### CHANGE PROPOSAL

**CP Number:** 08R2 **RFP #:** CPR 03

Project: Galveston ISD Weis Middle School Ph 1 Renovation

Description: Central Middle School restrooms 135 & 137 remodel. Excludes Boys restroom by SPED. Excludes HVAC controls Excludes Terrazo floor repair in corridor at Rm 137

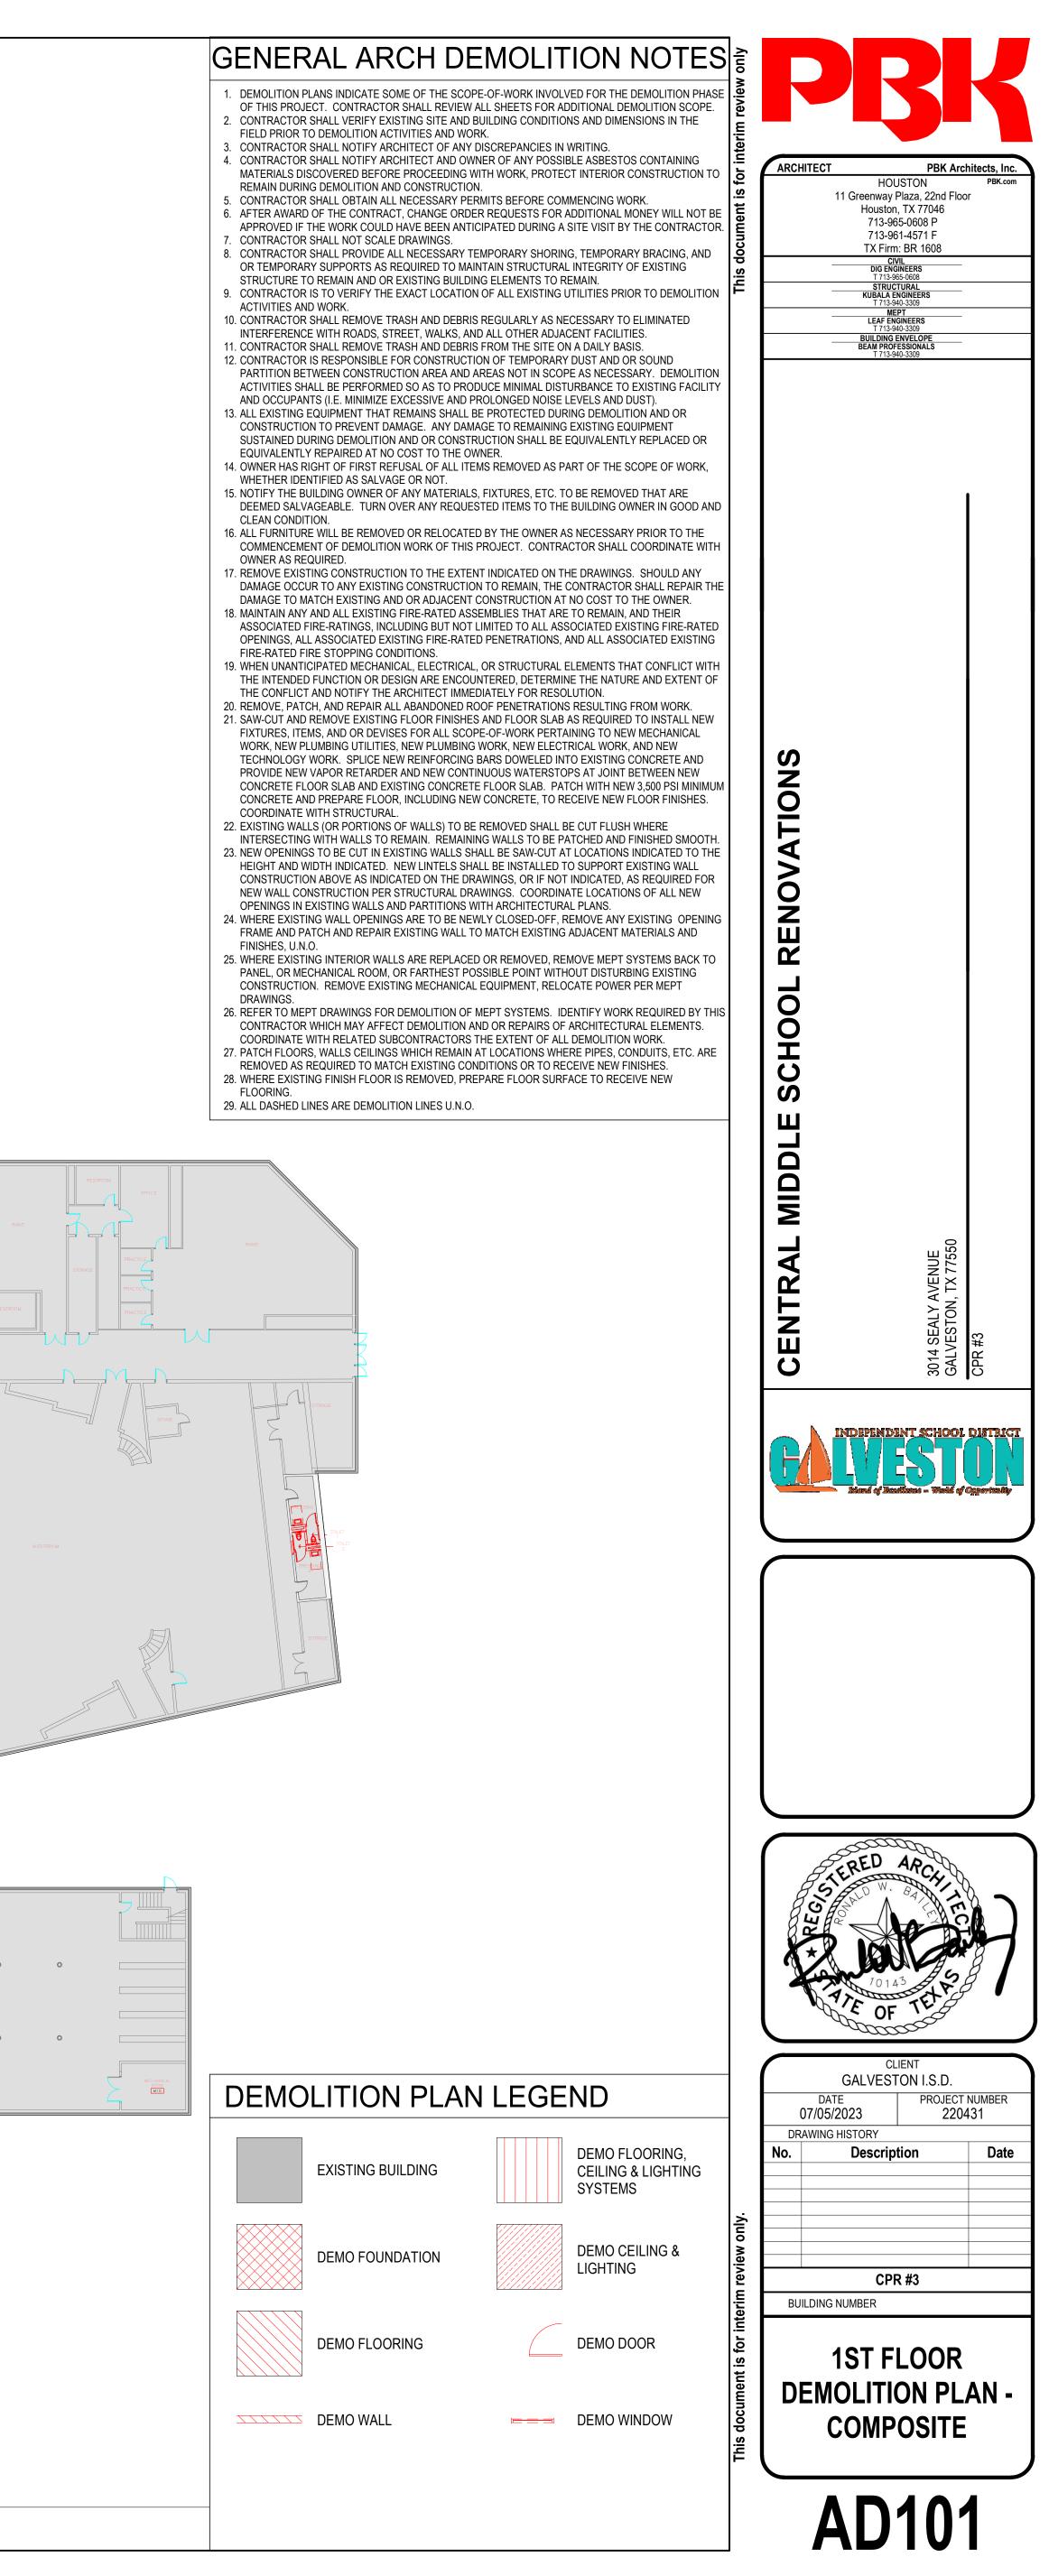
D4 REMOVE EXISTING WALL TILE COMPLETELY. PATCH AND REPAIR SURFACE FC SCHEDULED CONSTRUCTION	DR NEW
GIRLS RR 137		
<b>04</b> Girls Restroom @ Auditorium Enlarged Plan DEMO		
<b>  └ ⁻ </b>   1/4" = 1'-0"

Girls Restroom @ Auditorium Enlarged Plan

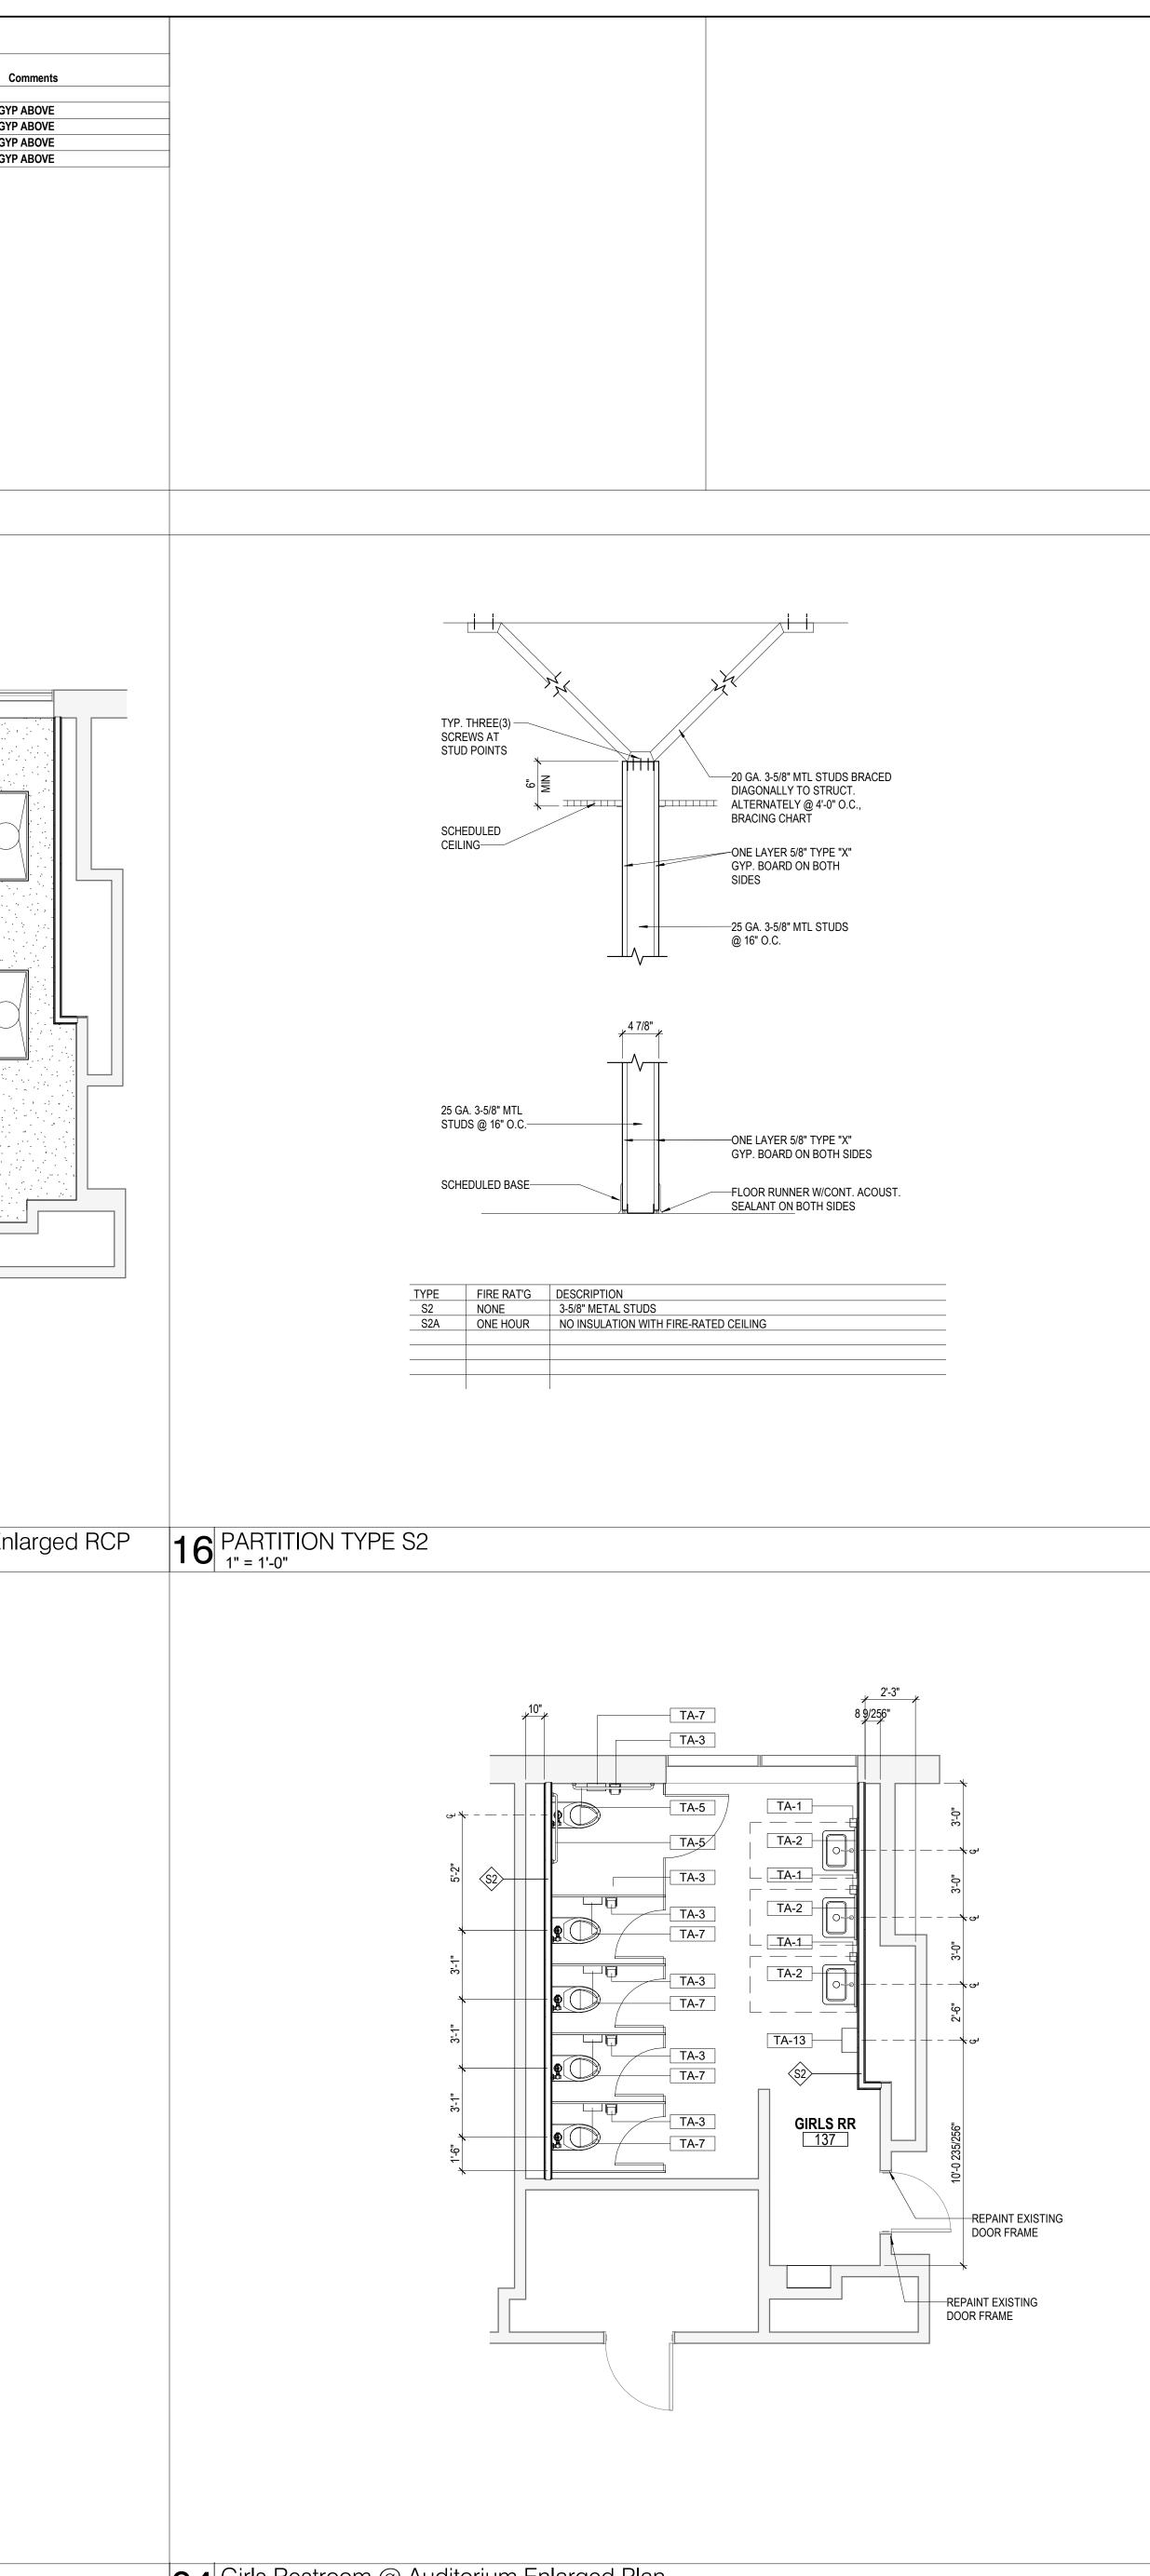
<ol> <li>PROVIDE AND INSTALL BULLNOSE</li> <li>REFER TO REFLECTED CEILING PL</li> <li>ALL ELECTRICAL DEVICE COVERS</li> </ol>		
<ol> <li>ALL CARPET PATTERNS TO RUN P</li> <li>PAINT ALL HOLLOW METAL DOOR</li> <li>FLOOR FINISH CHANGES SHALL O</li> <li>GENERAL CONTRACTOR TO SUBM</li> </ol>		
	TOILET ACCESSORIES         LABEL       DESCRIPTION       NOTES	
	TA-1SOAP DISPENSER, WALL-MOUNTED OFCITA-2LAVATORY MIRRORTA-3TOILET PAPER DISPENSER OFCITA-4PAPER TOWEL DISPENSER OFCITA-5GRAB BARS (AT TYPICAL WHEELCHAIR ACCESSIBLE WATER CLOSETS)	
	TA-6SANITARY NAPKIN DISPENSERTA-7SANITARY NAPKIN DISPOSALTA-13ELECTRIC HAND DRYER	
	NOTES: 1. ALL TOILET ACCESSORIES SHALL BE CONTRACTOR FURNISHED AND CONTRACTOR INSTALLED U.N.O. 2. COORDINATE FINAL LOCATIONS WITH ARCHITECT PRIOR TO INSTALLATION.	
	<ol> <li>VERIFY ALL HEIGHTS OF ACCESSORIES TO COMPLY WITH ALL APPLICABLE ACCESSIBILITY REQUIREMENTS.</li> <li>REFER TO ALL FINISHES AND COLORS IN FINISH SCHEDULE, VERIFY ALL PATTERNS WITH ARCHITECT.</li> <li>ALIGN MIRROR ON CENTER OF LAVATORY.</li> </ol>

# **MECHANICAL KEYED NOTES:**

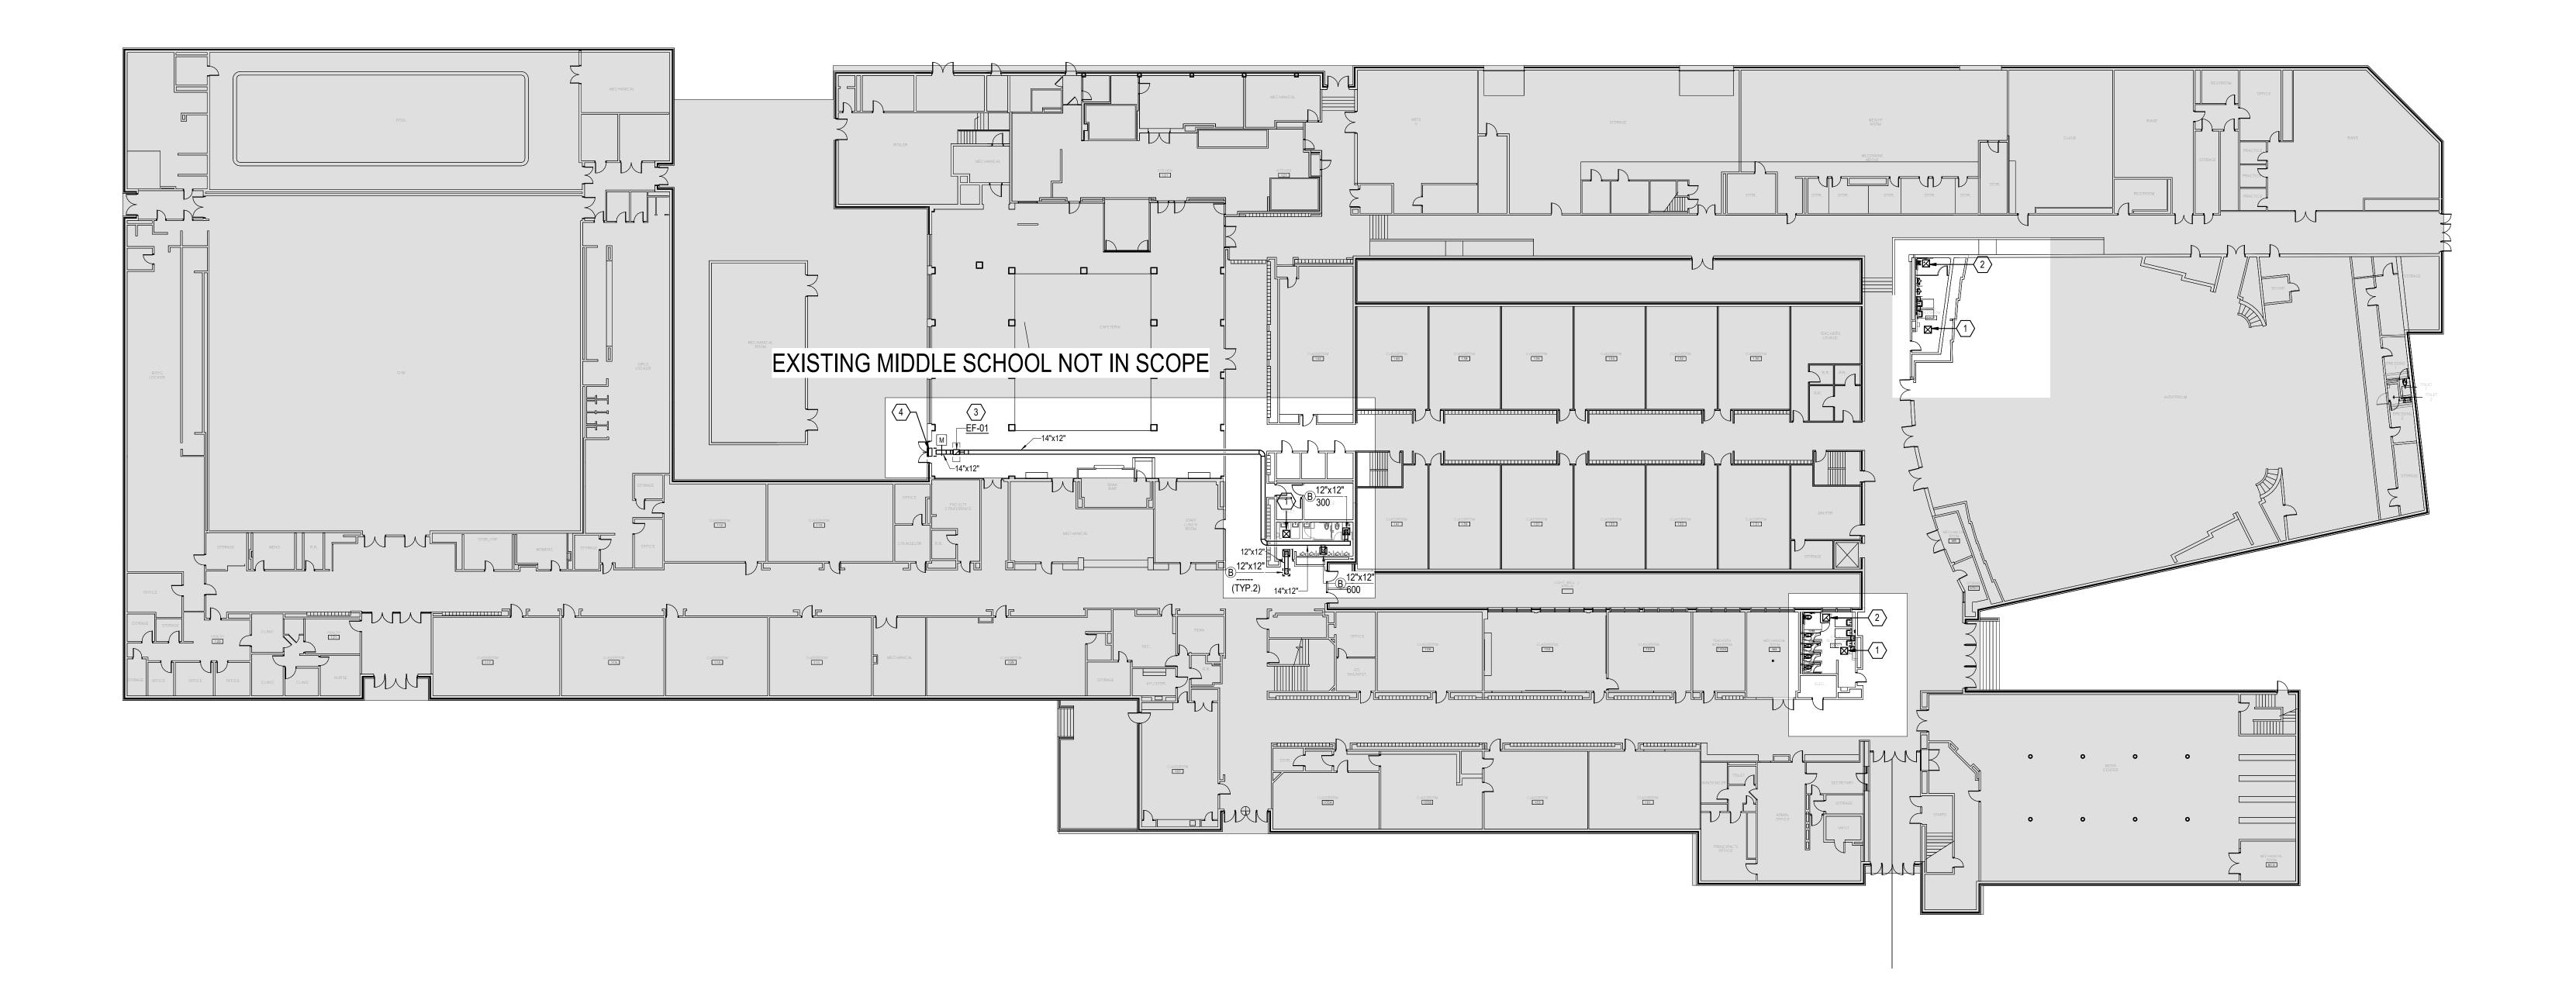
- 1 PROVIDE NEW SUPPLY AIR GRILLE AND CONNECT TO EXISTING SUPPLY DUCT WITH SIMILAR NECKSIZE AND TYPE OF GRILLE OF EXISTING. MATCH NEW AIR DEVICE WITH NEW REFLECTED CEILING PLAN, REFER TO ARCHITECT DRAWING.
- $\langle 2 \rangle$  provide New Exhaust Air Grille and connect to existing exhaust duct with similar Necksize and type of Grille of Existing. Match New Air device with New Reflected
- CEILING PLAN, REFER TO ARCHITECT DRAWING. PROVIDE NEW EXHAUST FAN. FAN SHALL BE MONITORED FOR STATUS AND ENABLE/DISABLE BY EXISTING BUILDING AUTOMATION SYSTEM. INTERLOCK FAN TO RUN WITH ASSOCIATED AIR HANDLING UNIT. INTERLOCK ASSOCIATED MOTORIZED DAMPER WITH FAN TO OPEN/CLOSE WHEN FAN IS ENERGIZED/DE-ENERGIZED.
- 4 28"x16" EXHAUST AIR LOUVER. REFER TO ARCHITECTURAL SPECIFICATION FOR FINAL FINISH AND LOCATION.
